Preliminary Consultation
MONTGOMERY COUNTY HISTORIC PRESERVATION COMMISSION
STAFF REPORT

Address:	3710 Bradley Ln., Chevy Chase	Meeting Date:	4/22/2026
Resource:	Non-Contributing Resource Chevy Chase Village Historic District	Report Date:	4/15/2026
Applicant:	Robyn Segal	Public Notice:	4/8/2026
Review:	Preliminary Consultation	Staff:	Dan Bruechert
Proposal:	Partial Demolition, Building Addition, Accessory Structure Modifications, Tree Removals, and Hardscape Alteration

Figure 5: The proposed garage modifications, with the existing roofline shown as a dashed line.

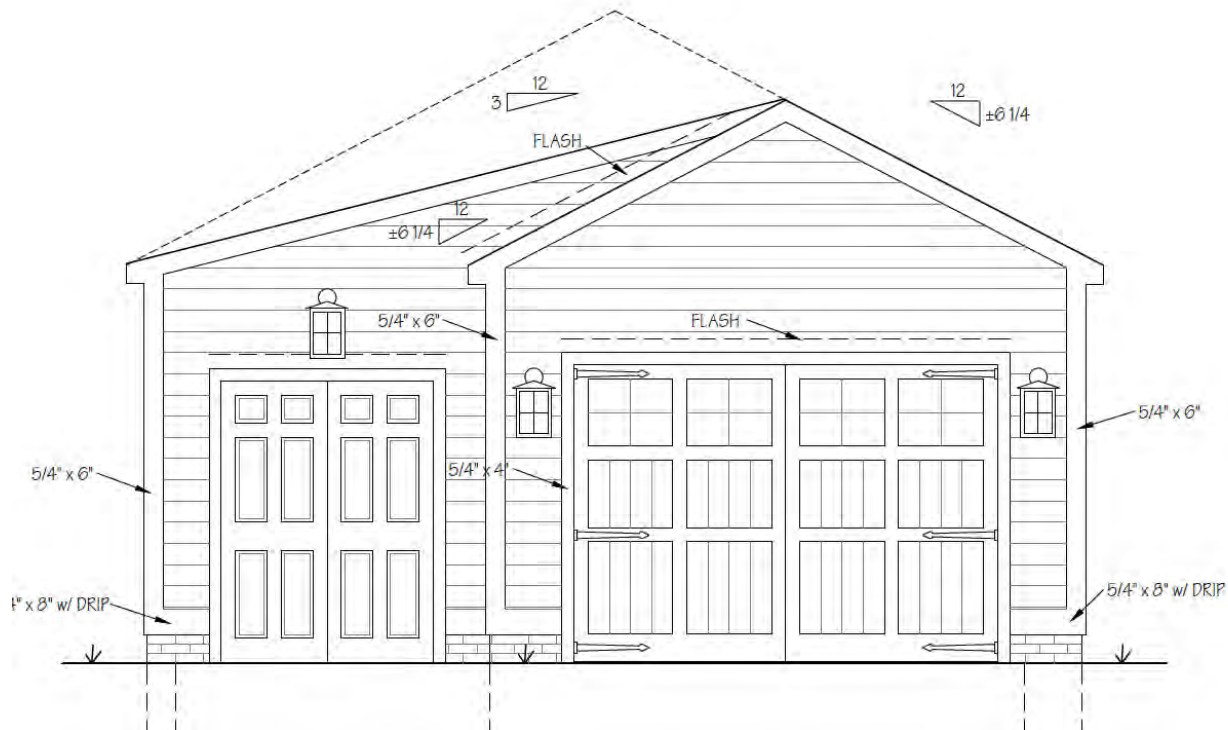
As a Non-Contributing Resource, the *Design Guidelines* allow for extensive alterations up to and including demolition. Based on the guidance provided in the *Design Guidelines*, most alterations to Non-Contributing garages should be approved as a matter of course. Nevertheless, Staff finds the proposed changes to the garage are in keeping with the character of the site and surrounding historic district. Staff finds detailed specifications for the garage doors and exterior lighting are required for a complete HAWP application.

Staff requests feedback from the HPC on the proposed alterations to the garage.
